L-2003-239
10 CFR 50.90

Re: Turkey Point Units 3 and 4
Docket Nos. 50-250 and 50-251
Spent Fuel Pool Cask Area Rack Amendment
Clarification on RAI Response to NRC Questions 10a and 23

Clarification to the Response for RAI Question #23

Figure 1
Correct Unit 3 Rack Orientation

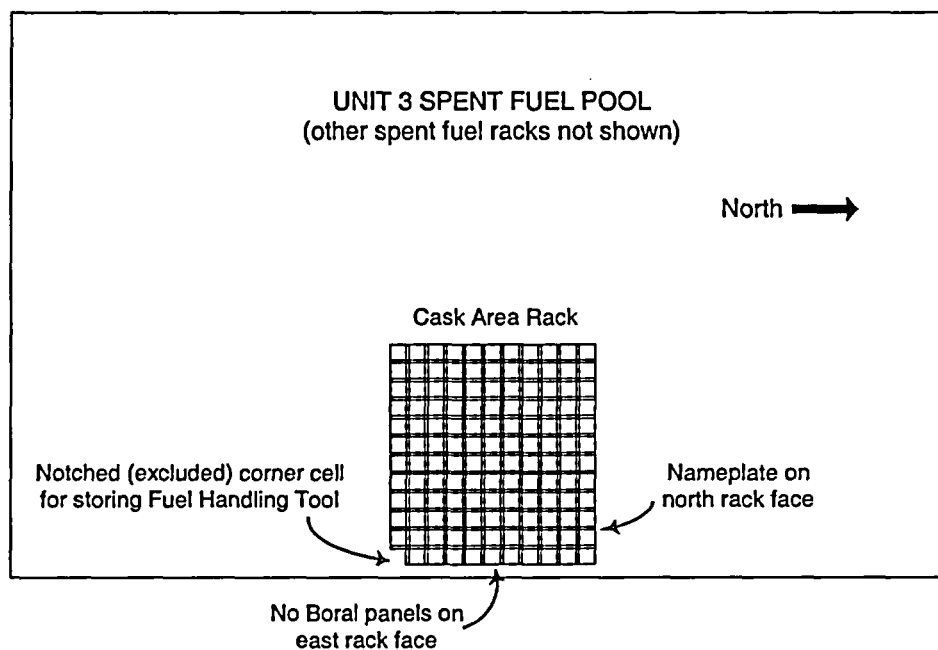
The installation procedure for the Turkey Point cask area racks will include Quality Control (QC) hold points. The purpose of the QC hold points will be to verify the racks (one per unit) are correctly oriented by compass direction both before and after their installation in each unit's spent fuel pool. Correct rack orientation is mandatory because one of the four rack sides does not contain Boral neutron-absorbing panels, and the rack criticality analysis requires that the side without Boral panels must face the east pool wall. Because of the rack's rectangular shape and size, it is physically possible to install the rack in either of two rack orientations in the spent fuel pool, 180 degrees apart. Hereafter, these two orientations are referred to as the 'correct' and the 'backward' orientations. The rack is not allowed to be installed in the backward orientation because the rack side without Boral panels would then face other fuel storage racks instead of the pool wall, invalidating the rack criticality analysis.

See Figures 1 and 2 on the following page for the correct rack orientation in the Unit 3 and Unit 4 spent fuel pools, respectively.

Note that on both units, the rack face with no Boral panels faces the east pool wall; the notched (excluded) corner cell is adjacent to the east pool wall; and the rack nameplate is on the north rack face.

- With the cask area rack on the leveling pad located under the cask handling crane, verify that the rack nameplate is facing north (the nameplate is located near the top of the north rack face, near the northeast corner).
- Verify that the nameplate reads "Turkey Point Unit 3". ["Unit 4" in the Unit 4 procedure]
- Verify that the notch (excluded cell) in the rack corner is in the southeast corner of the Unit 3 rack. [northeast corner of the Unit 4 rack]

2. Following rack installation in the spent fuel pool cask area, a QC hold point will require verification of the following step:
 - Verify by visual observation that the notch (excluded cell) is adjacent to the east pool wall, in the southeast corner of the Unit 3 rack. [northeast corner of the Unit 4 rack]
